## Body, general

### Model 107

## Doors

### Doors, model 107

Fig. 72/1 Outside door handle

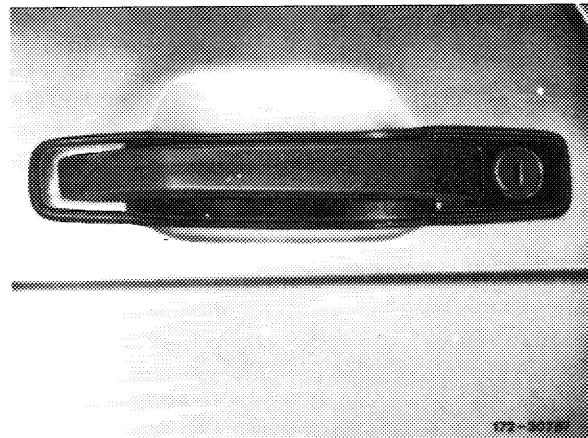
The outside door handles from the model 126, with some modifications, are installed. The door outer sheetmetal includes a door handle recess.

Door lock and striker are new, therefore, the B-pillar was modified.
